Re: St. Lucie Plant Unit 1  
Docket No. 50-335  
Renewed Facility Operating License No. DPR-67

Response to NRC Reactor Systems Branch Request for Additional Information  
Regarding Extended Power Uprate License Amendment Request

### **Response to Request for Additional Information**

Figure 1: k-eff vs. H/X plot

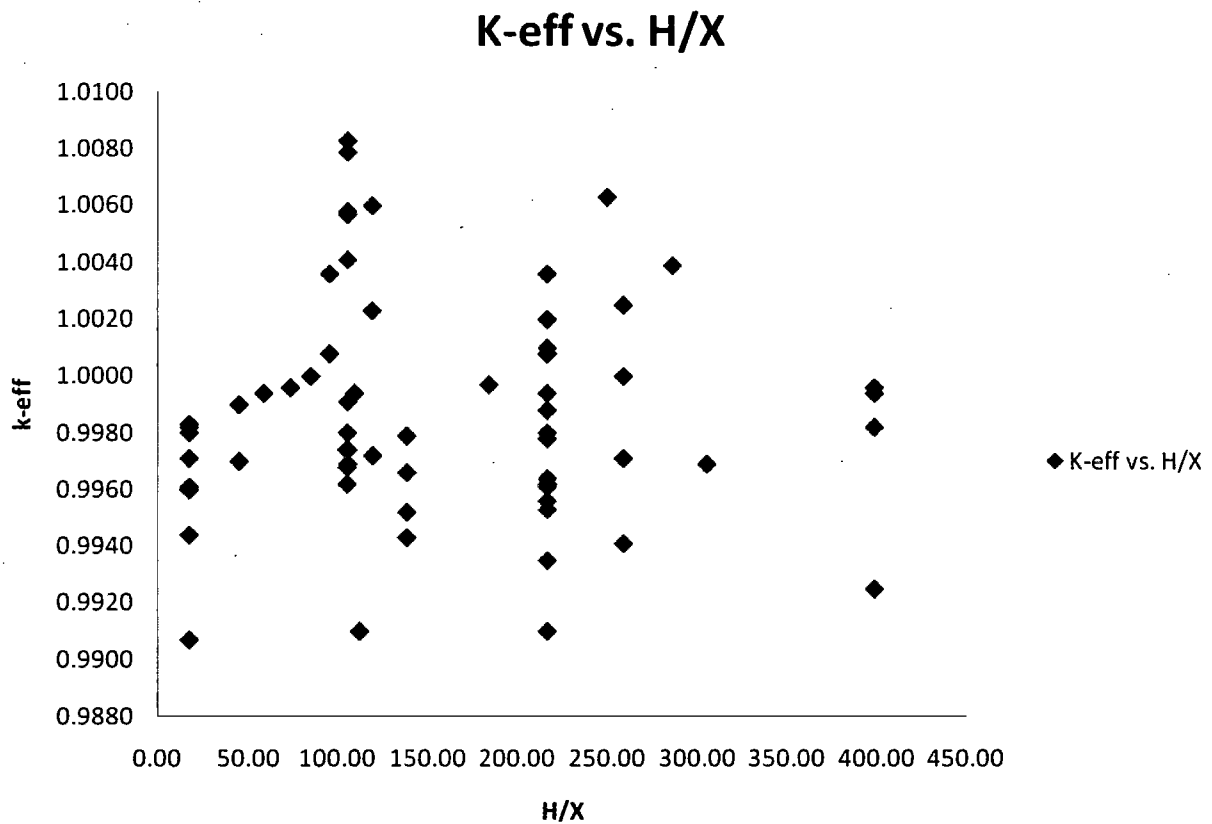
**The optimum moderation case where the new fuel vault is subjected to low density moderation (e.g., fog or foam) was analyzed at 9 percent water density. Discuss and justify the applicability of the MCNP4a validation at these low density moderator conditions.**

In response to the NRC RAI regarding benchmark calculations for optimum moderation case, MCNP4a benchmark calculations have been updated with 8 new experiments. These 8 new experiments represent the most densely packed module and consist of a 15x17 matrix of fuel pins (less four corner pins) loaded on a triangular pitch. This module is referred to as triangular or T type. This T type experimental configuration results in an H/X of 17.43, where H/X is the atom ratio of moderator to fuel. The H/X for the optimum moderation condition (9% water density) for the new fuel vault is 10.04. The following represents a description of the 8 new experiments.

In order to satisfy the normality assumption, Pearson's chi-square ( $\chi^2$ ) test [Reference 1] is employed on the set of 64 experiments. Additionally, linear trend analysis is performed to determine whether there is any linear relationship between the MCNP calculated k-effs and H/X. Based on the coefficient of determination ( $R^2=1.75E-07$ ), it is determined that there is no significant linear relationship between calculated k-effs and H/X [Reference 1]. Figure 1 presents the distribution of the k-eff values versus the trending parameter, which in this case is the H/X. This plot also visually confirms that there is no significant linear trend. Since there is no trend, extrapolation outside the H/X range, especially to 10.04 from 17.43 for the new fuel vault, is acceptable and therefore the bias and bias uncertainty calculated above are applicable for the new fuel vault calculations. Additionally, NUREG/CR-6698 states that (in Section 5) 10 percent extrapolation from the validation data (H/X range used is 17.43-398.69) is permissible.

The max total k-eff is increased by ~41 pcm, which is rather insignificant. Note that for all the new fuel vault calculations, the steel rack structure is conservatively replaced by water in the MCNP model.

**Figure 1 – VFRAs Core Locations**

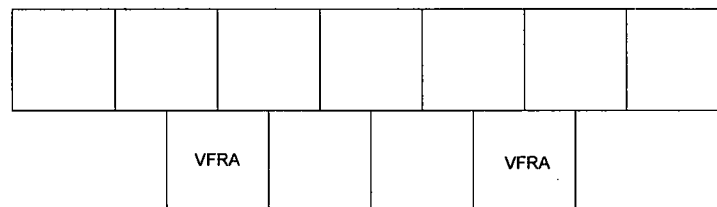
**Demonstrate that the presence of vessel flux reduction assemblies (VFRAs) during depletion do not lead to higher reactivity of the surrounding assemblies as compared to depletion without VFRA.**

A total of sixteen (16) VFRAs were used during four cycles of operation from 1991 through 1997; eight were initially loaded in Cycle 11 and reloaded for Cycle 12, and a different set of eight were initially loaded in Cycle 13 and reloaded for Cycle 14. All sixteen VFRAs were loaded on corners of the core periphery flats ("dog ears") for both cycles of operation. Note that each corner of the core periphery flats only has one face adjacent location (also on the core periphery), and two locations on the semi-periphery that are "half" face-adjacent. The figure below depicts the core locations for the VFRAs.

The VFRAAs operated at very low power levels due to three factors – (1) their low initial enrichment, (2) hafnium absorber rods, and (3) located on the core periphery. Typically, the VFRAAs had relative powers less than 50% of typical peripheral assemblies.

With regards to spectral effects caused by the presence of VFRAAs and potential impact on neighboring fuel assemblies, no deviations in core response was observed during the cycles with VFRAAs. Note that there were only a total of 96 neighboring fuel assemblies (16 VFRAAs X 2 cycles X 3 neighboring locations).

Generic studies [References 1, and 2] indicate that one of the more dominant operating parameters that results in higher reactivities is the moderator temperature used for depletion. As discussed in the criticality report HI-2104714 Revision 1 Section 7.4, the moderator temperature used for depletion is taken as the peak power assembly exit temperature for all cycles of operation. Recall that the VFRA neighboring assemblies are on the periphery or semi-periphery, thus operated at low power for at least one cycle of operation. Therefore, any potential reactivity impact caused by the VFRAAs would be bounded by the moderator temperature used for depletion in the criticality analysis.
